SUBJECT: Response to Request for Additional Information
Request for Relief ANO1-ISI-021
Arkansas Nuclear One, Unit 1
Docket No. 50-313
License No. DPR-51

**Response to Request for Additional Information
Relief Request – ANO1-ISI-021**

Figure 1

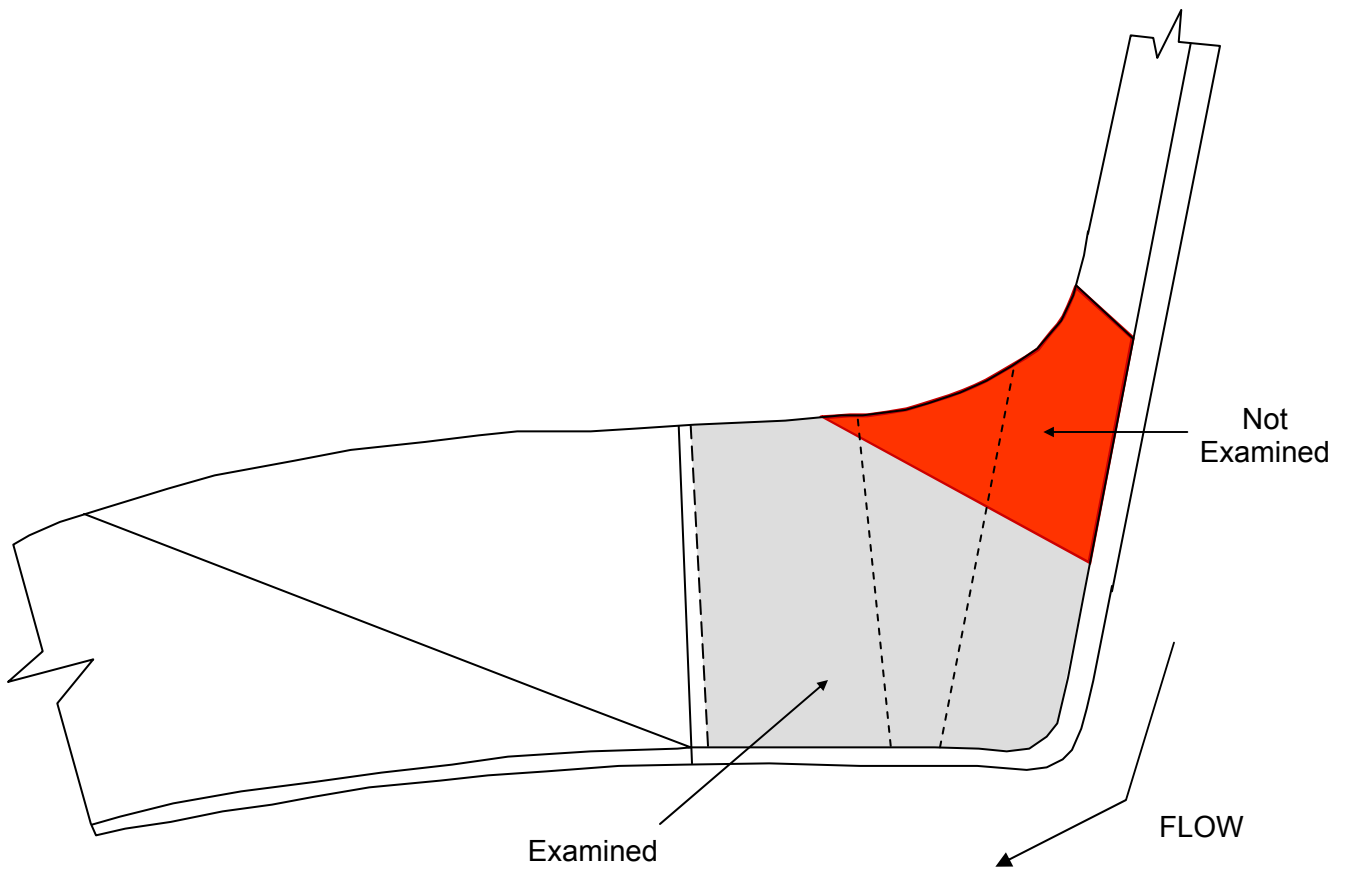
6. There appears to be a discrepancy between the stated coverage percentages and the “uninspected area” shown in the figures. How was coverage calculated? Please provide a coverage map showing the areas that were missed.

Component 05-012 - Pressurizer Spray Nozzle to Head weld, was reported to have cumulative coverage of 36.6%, which is the average of the four scans taken each with the 45° and 60° angle beam transducers across the base material on the nozzle side, the weld and the base material on the head side of the component.

Scan illustrations appear to indicate more coverage than the reported 36.6% due to the 60° angle providing approximately 69% scan coverage in one direction across the weld from the vessel head side. The cumulative scan coverage is reduced considerably because the scan from the nozzle side could not be performed, and the circumferential scans could not be performed all the way across the Code-required surface area.

Refer to attached Figures 1 and 2 which illustrate the extent of examination volume that was interrogated to some extent with the ultrasonic process by at least one examination angle.
